Re: Lot 1 (22 Oakwood Drive), Beacon Falls, Connecticut

I have reviewed the Regional Water Authority comment letter and would like to respond by providing the missing information that they are requesting. This project has received specific approval from the local health dept. for phase 1, and the test hole data has been approved for the other phases. A Stormwater pollution control plan has also been prepared for the Stormwater general permit for construction activities per the DEEP requirements.

The Regional Water Authority Comments

HOPP BROOK ESTATES FINAL SITE PLANS

SP-1

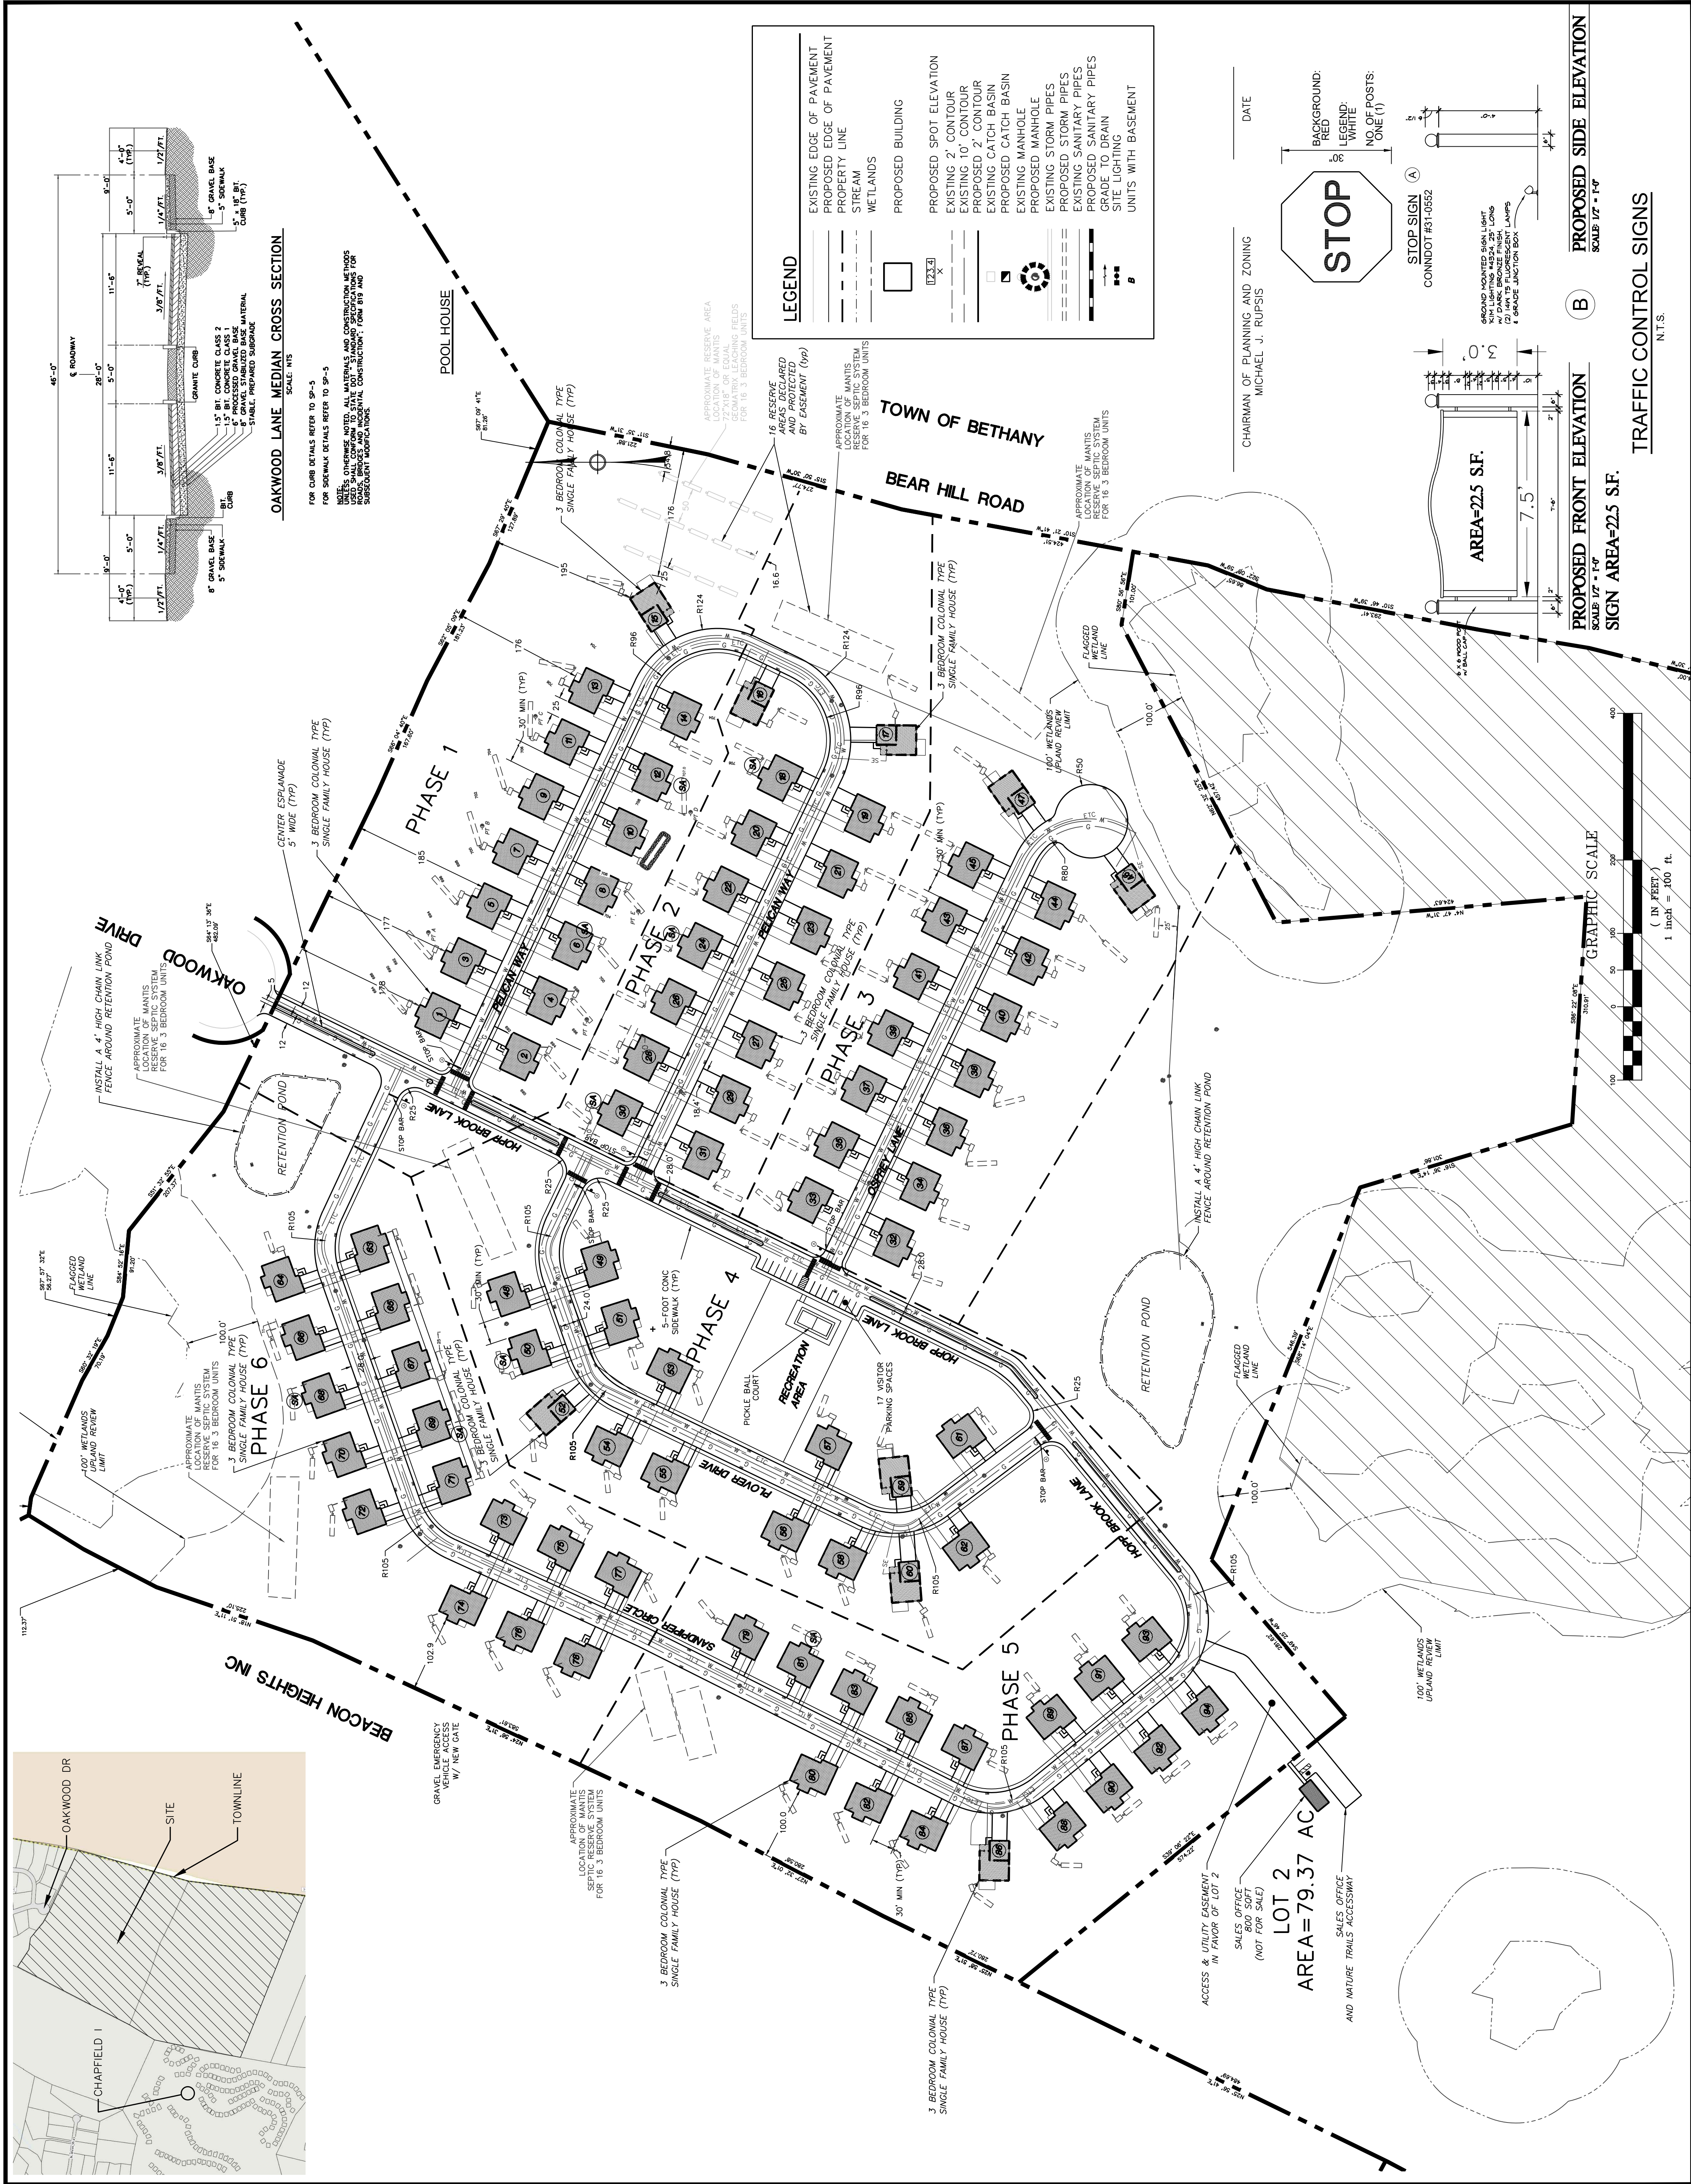
1. The RWA's concerns regarding this application are related to the lack of information in the site plan regarding septic systems. The majority of septic system effluent will be directed to the public water supply watershed portion of the property. The site plan does not show septic tanks, a connection to the leaching fields, or a reserve leaching field. There is no information regarding percolation testing or test pits. The proposed septic systems do not appear to be individual systems and may be considered a community septic system under the jurisdiction of the CT Department of Public Health or the CT Department of Energy and Environmental Protection, depending on design flows. Concentrating the septic system effluent into small areas close to the RWA property line could pose a threat to groundwater quality, specifically bacteria and nitrogen pollution. The application also contains conflicting information relating to connecting the residences to a municipal sanitary sewer system

R. The development is a compact or cluster development of 94 single-family homes on 135 acres. The project proposes 94 individual septic systems near each house for a 3-bedroom house. The project has been divided into 6 phases or sites. A test hole investigation has been conducted and witnessed by the Naugatuck Valley Health Department (NVHD) for all 94 proposed homes. These system locations are shown

on Sp-1 of the Site plan set. (Attached as Appendix A) Detailed septic designs for Phase 1 are shown on plans PSP-1.1, PSP-1.2 & PSP-1.3. (Attached as Appendix A) This includes soil and percolation test data and are part of the plan set. NVHD has determined that all the test holes are suitable for septic systems and has approved the detailed design of Phase 1 for construction. (Approval letter attached as Appendix F)
